TECHNICAL BULLETIN

HN402 TRUCK SUSPENSION HN402 IMPROVEMENT

No: TRUCK AUS-008

Subject: *Product Update*

Description

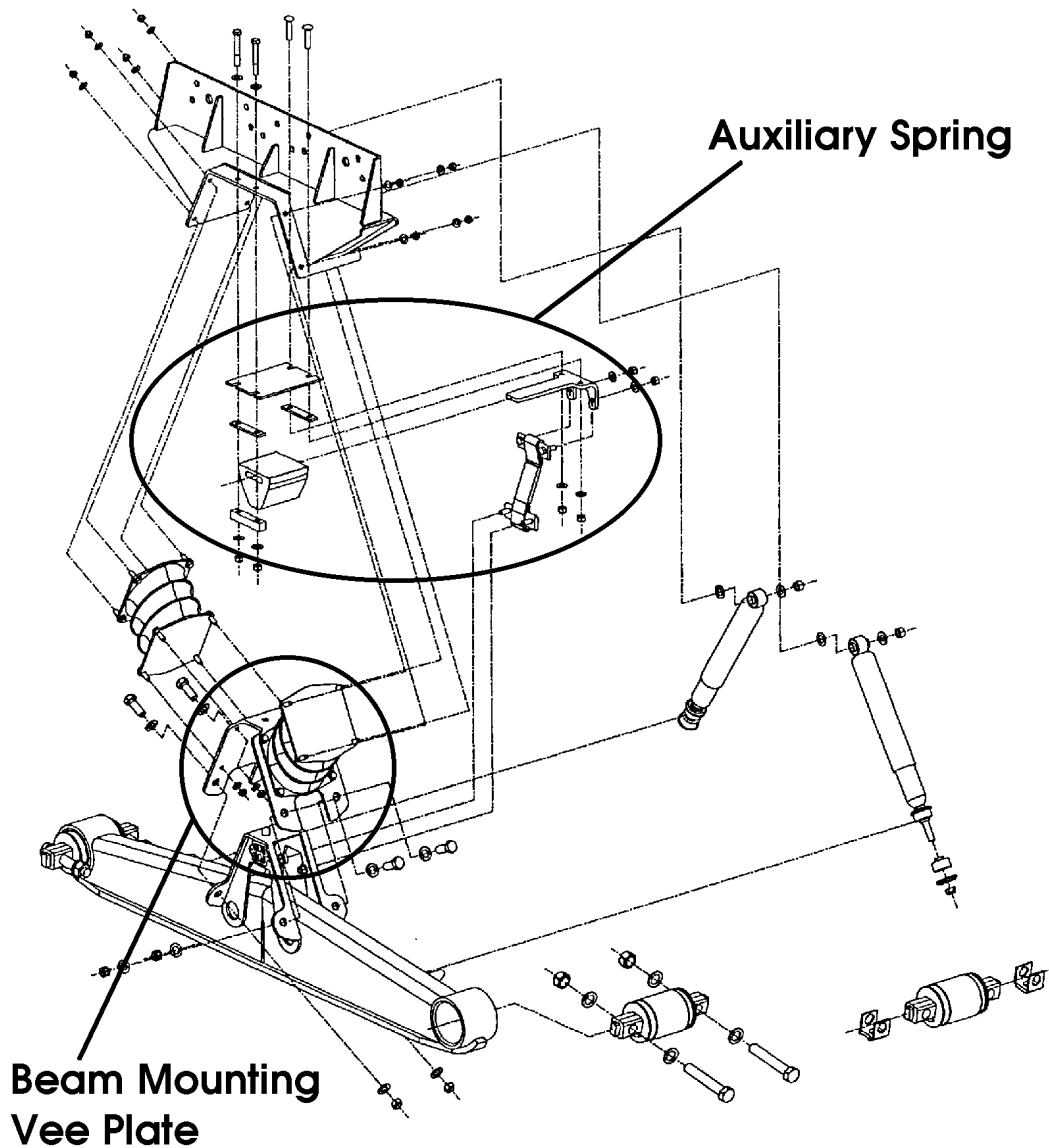
As part of our continuous product improvement program, Hendrickson is currently introducing a new Beam Assembly mounting system and Auxiliary Spring Assembly in all HN402 suspensions.

The new Beam Assembly including Vee plate is a direct replacement for the previous beam assembly. Beam assembly 98743-001 is replaced by 98969-004. The main feature of this change is that the bolster springs are bolted to a Vee plate, which is then bolted to the beam making for easier disassembly and servicing. See the above diagram.

The Auxiliary Spring is a more noticeable change with a new look and a more durable material with simpler construction.

This new auxiliary spring provides a greater resistance to taking a "set" so will maintain its performance without requiring adjustment for longer. When adjustment is required, the new mounting method simplifies this process.
